Modifications to Accor Sofitel Hotel Site 4A, Olympic Boulevard Sydney Olympic Park

SECTION 75W APPLICATION

Submitted to: NSW Department of Planning

Date: 17 January 2007

1 SOUTH ELEVATION
1:100

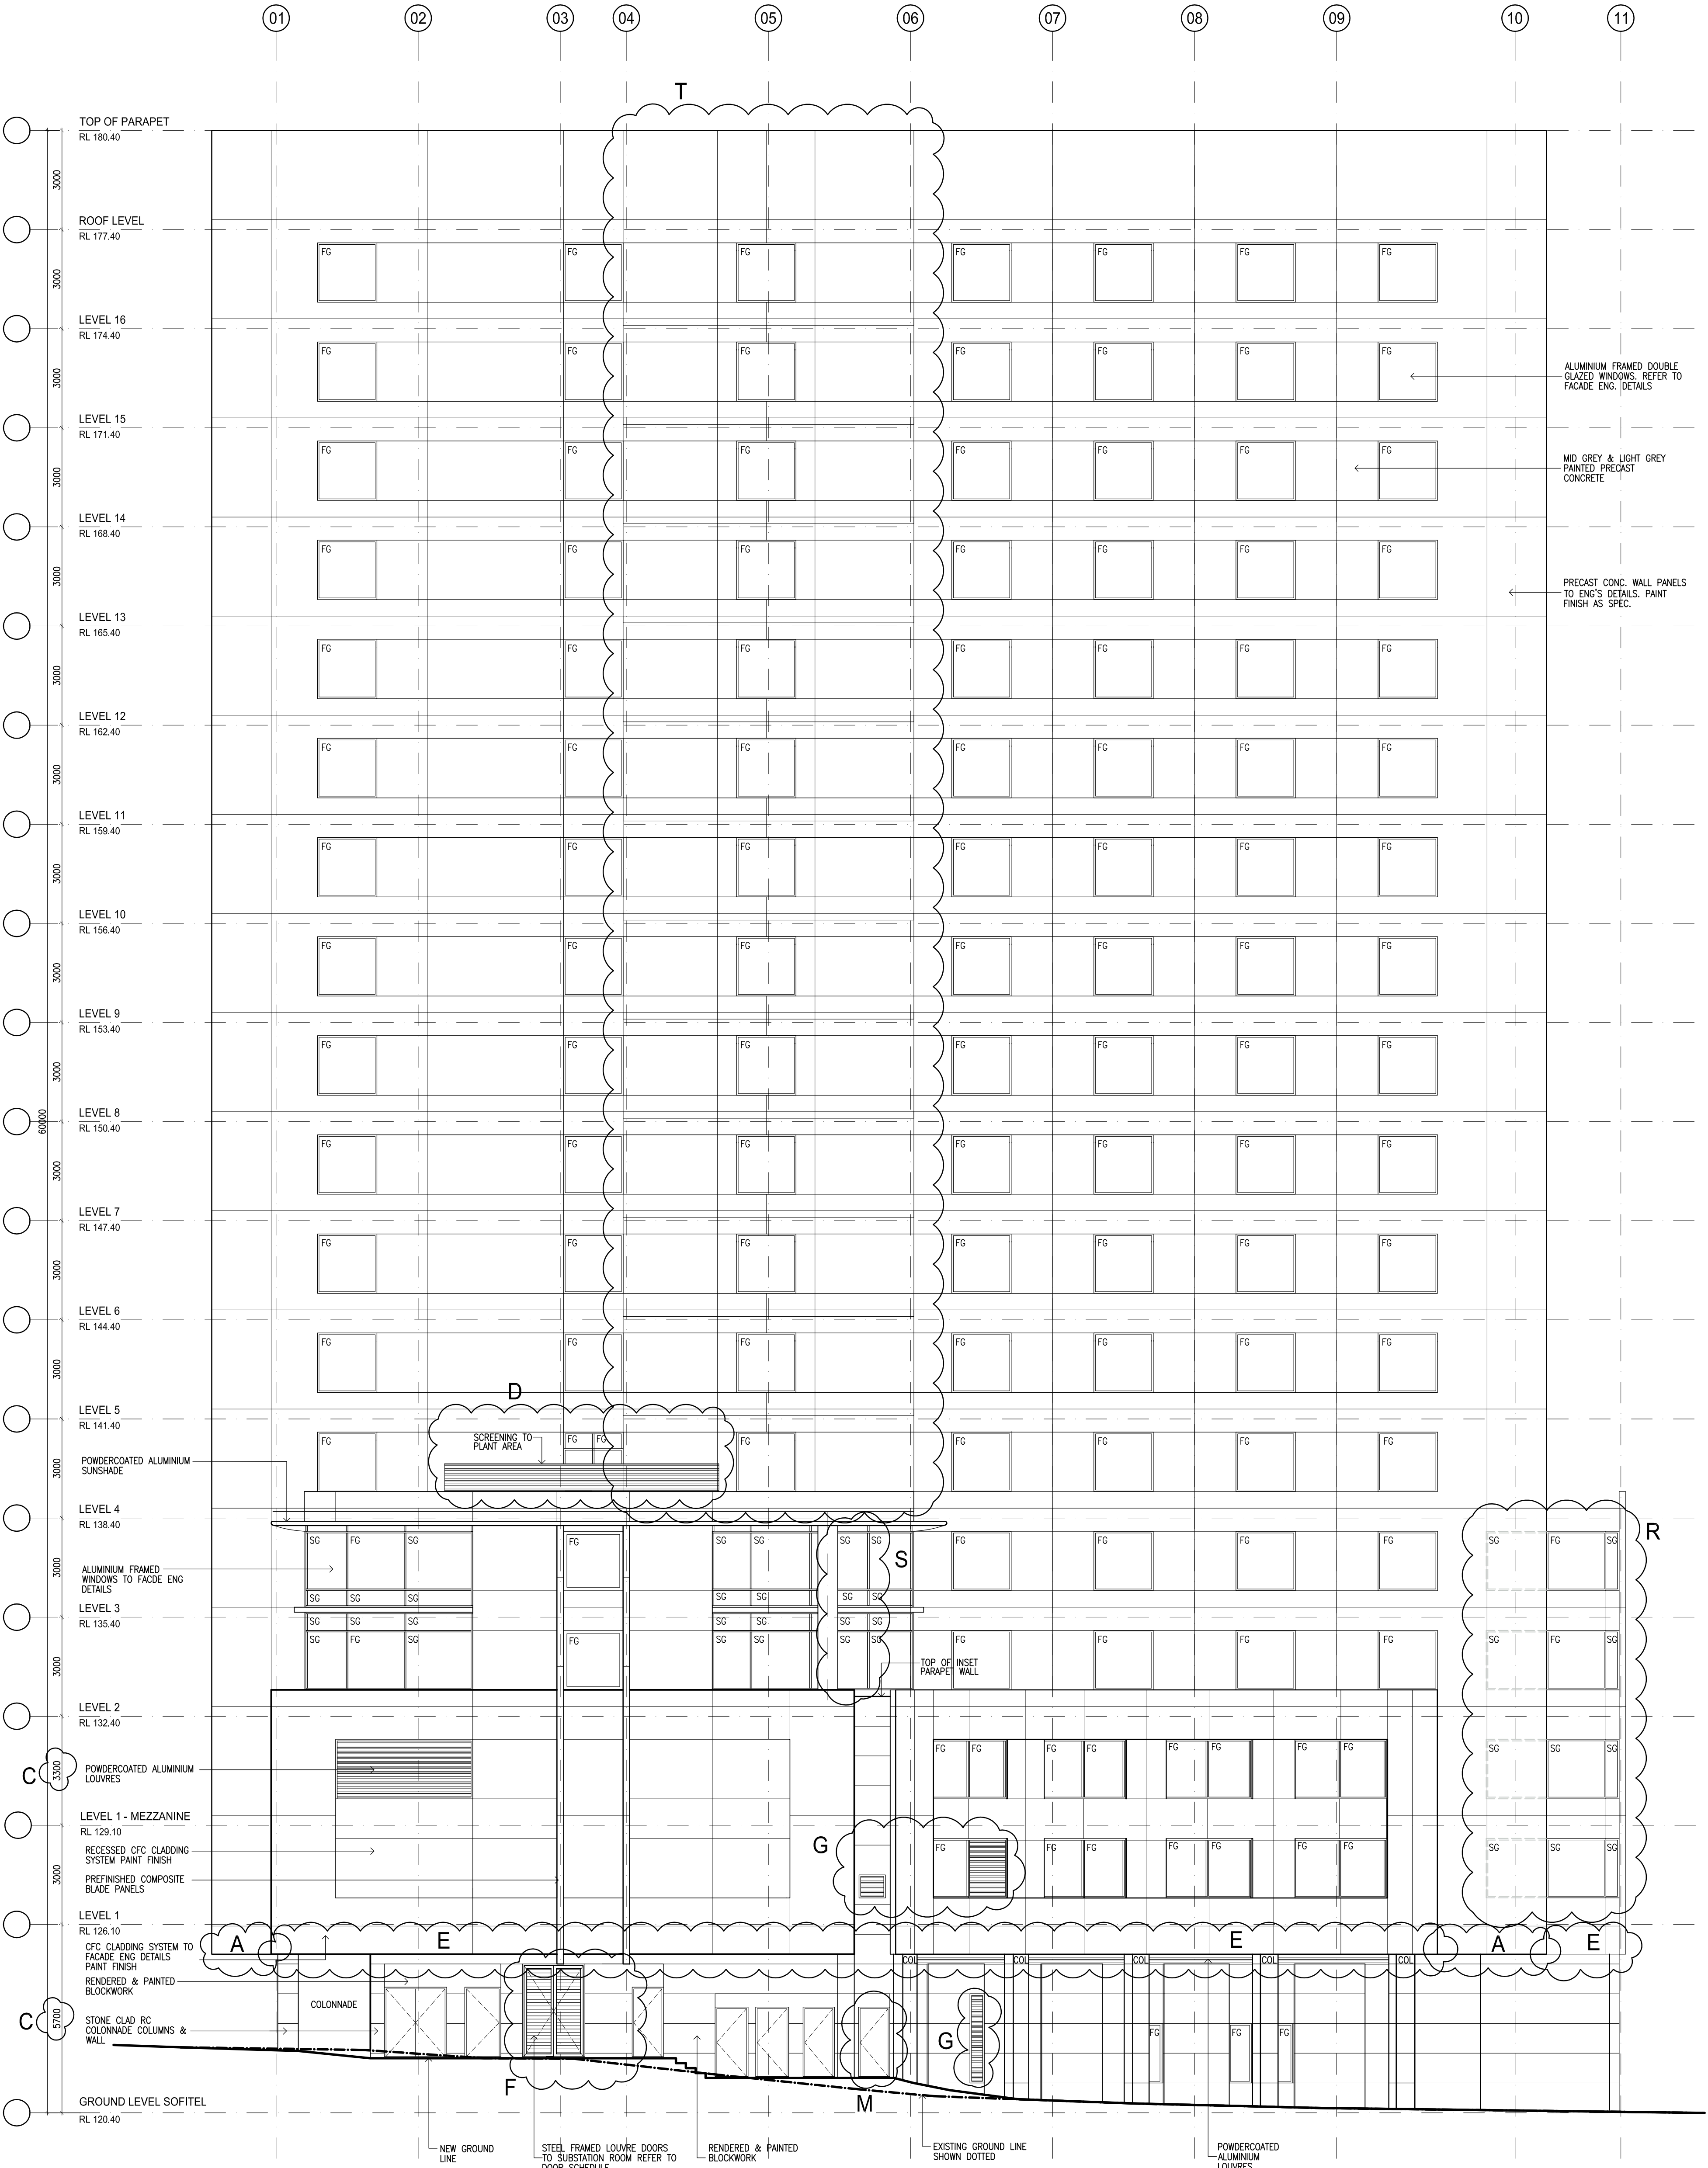
A: DENOTES DROP OF HEM OF PRECAST BY 300MM.
C: DENOTES CHANGE IN DIMENSION
D: DENOTES ADDITION OF PLANT ENCLOSURE

E: DENOTES DROP IN CLADDING BASE BY 300MM.
F: DENOTES INCREASED HEIGHT OF DOORS AND DELETION OF
FEATURE BLADES AT GROUND LEVEL
G: DENOTES INCLUSION OF LOUVRE
M: DENOTES FIRE CONTROL ROOM DOOR RELOCATED

R: FENESTRATION ADJUSTED.
S: DENOTES SPANDREL GLASS IN LIEU OF FIXED GLAZING.
T: PANEL JOINTS / GROOVES ADJUSTED.

Project
SO F I T E L
SYDNEY OLYMPIC PARK
OLYMPIC BOULEVARD HOMEBSH
CHANGES TO EA-APPROVED FACADE
WEST ELEVATION

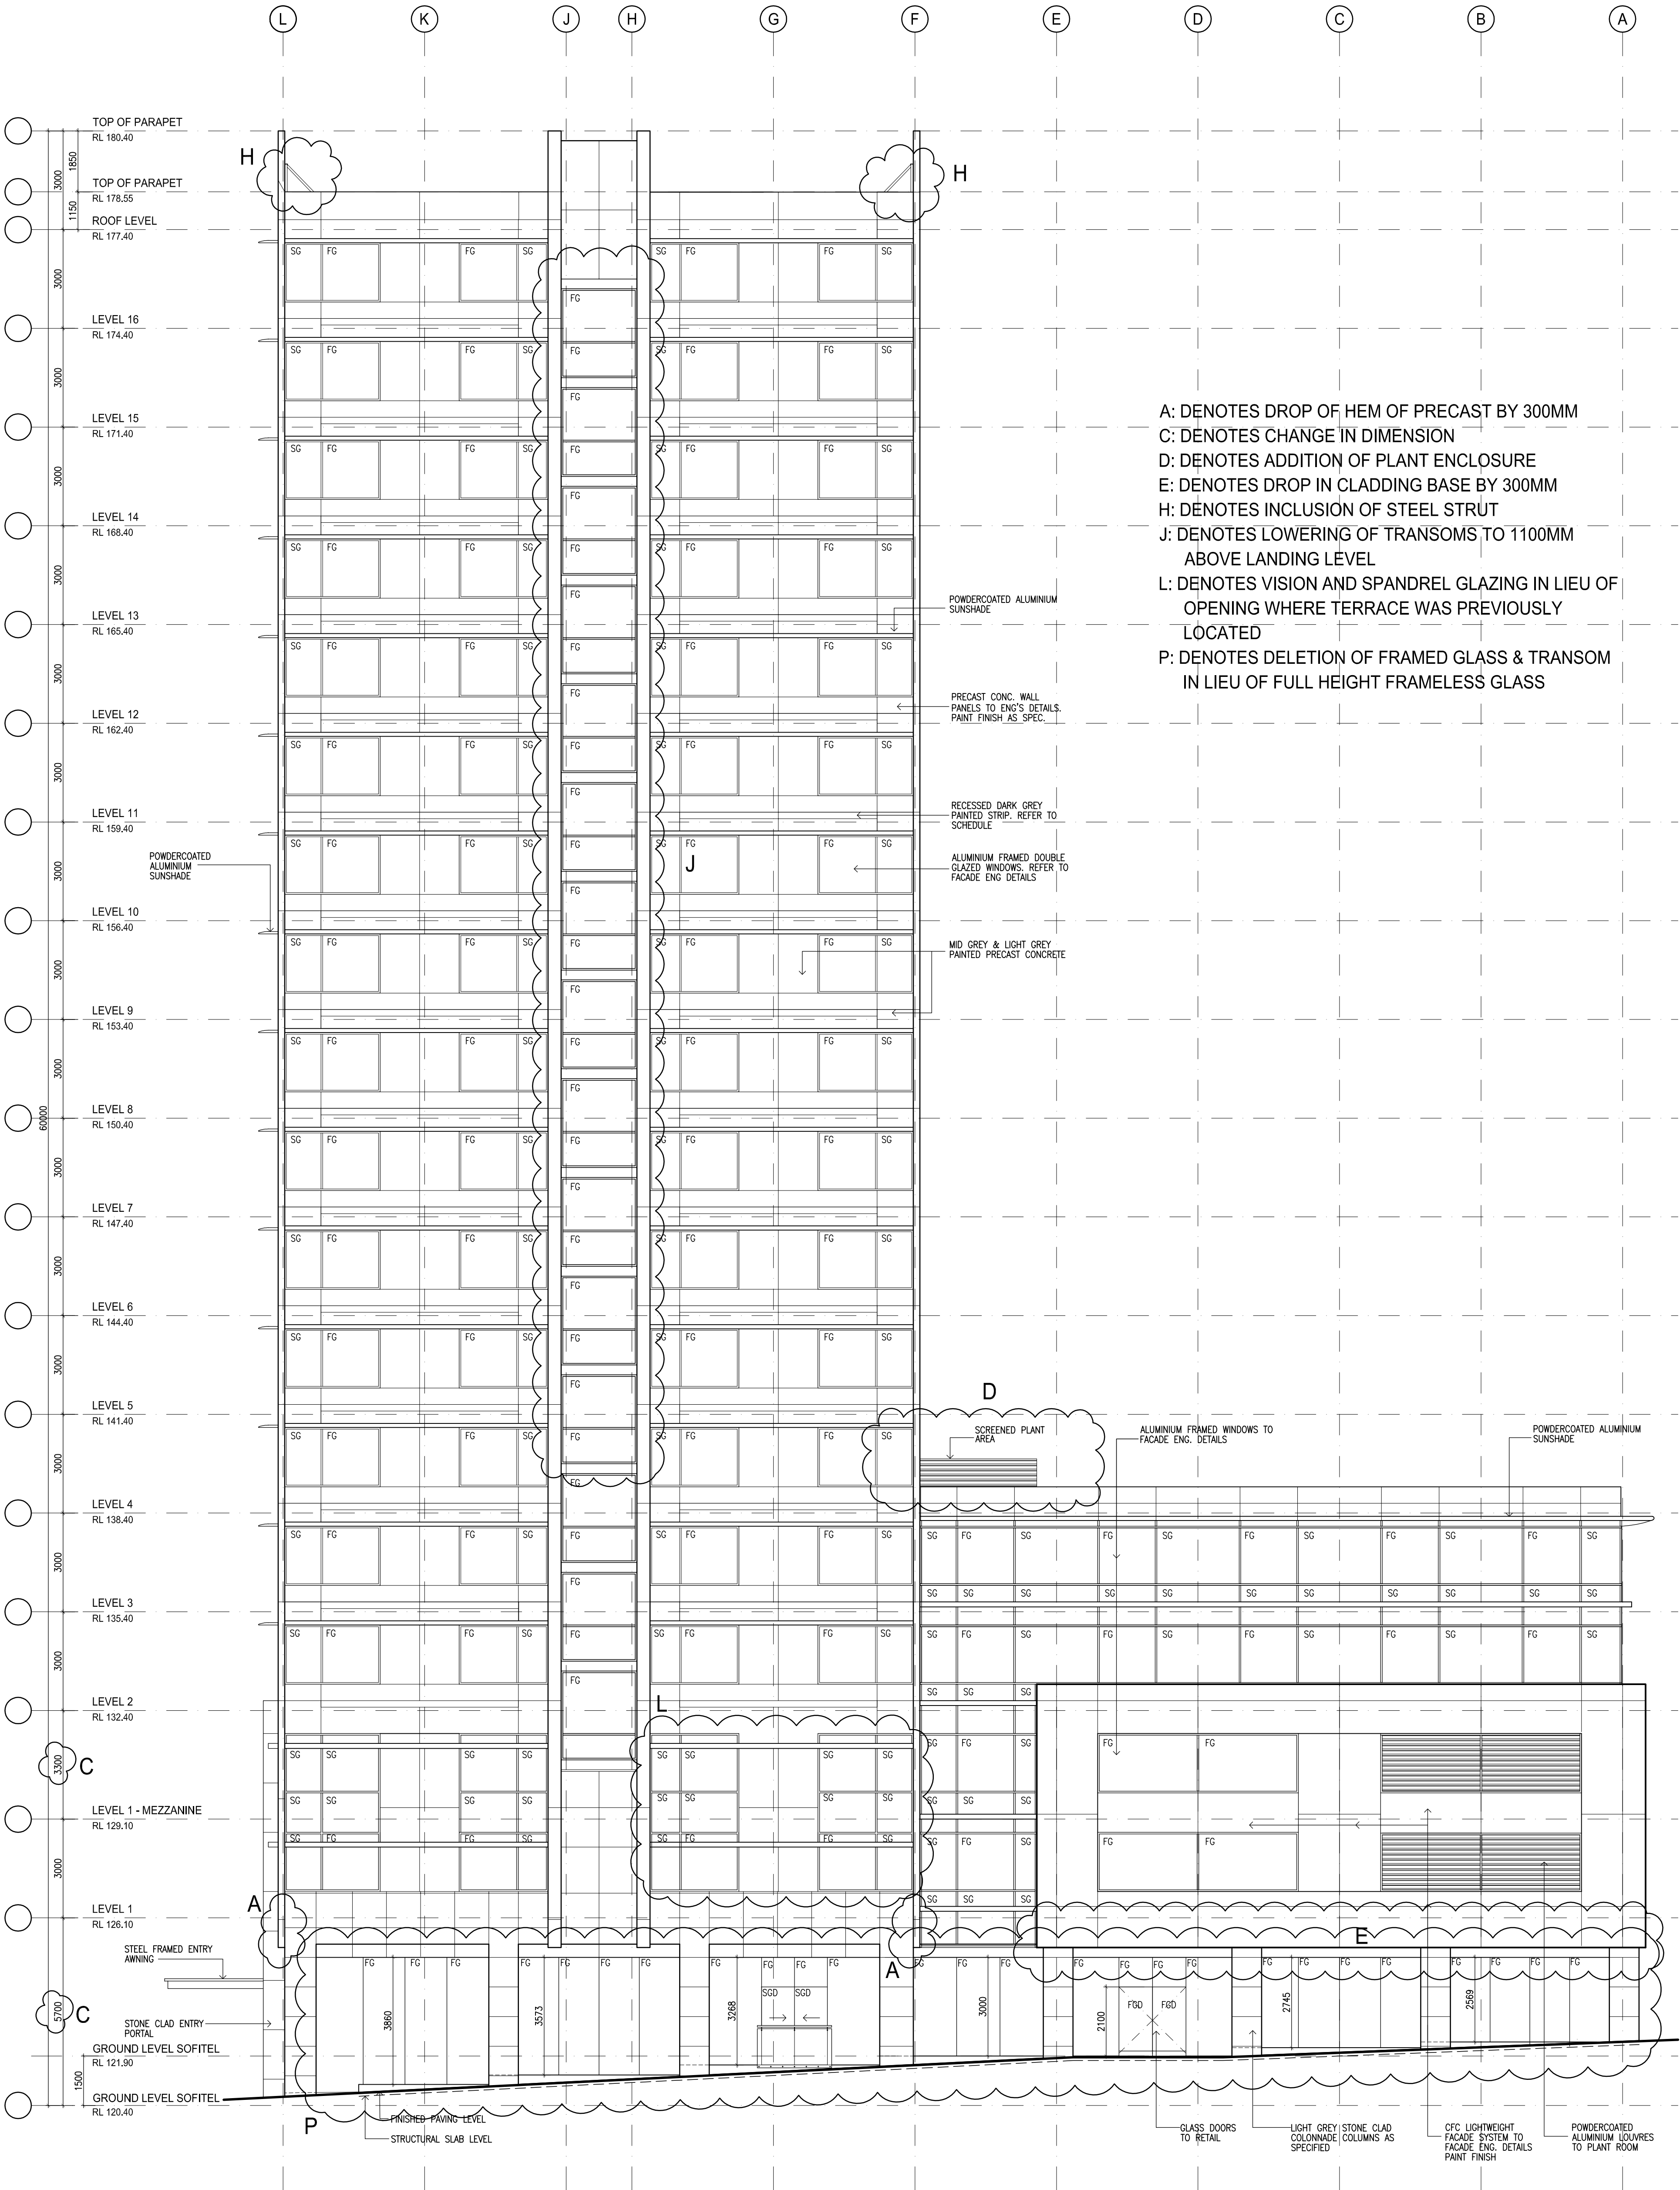
- A: DENOTES DROP OF HEM OF PRECAST BY 300MM
- C: DENOTES CHANGE IN DIMENSION
- D: DENOTES ADDITION OF PLANT ENCLOSURE
- E: DENOTES DROP IN CLADDING BASE BY 300MM
- H: DENOTES INCLUSION OF STEEL STRUT
- J: DENOTES LOWERING OF TRANSOMS TO 1100MM ABOVE LANDING LEVEL
- L: DENOTES VISION AND SPANDREL GLAZING IN LIEU OF OPENING WHERE TERRACE WAS PREVIOUSLY LOCATED
- P: DENOTES DELETION OF FRAMED GLASS & TRANSOM IN LIEU OF FULL HEIGHT FRAMELESS GLASS
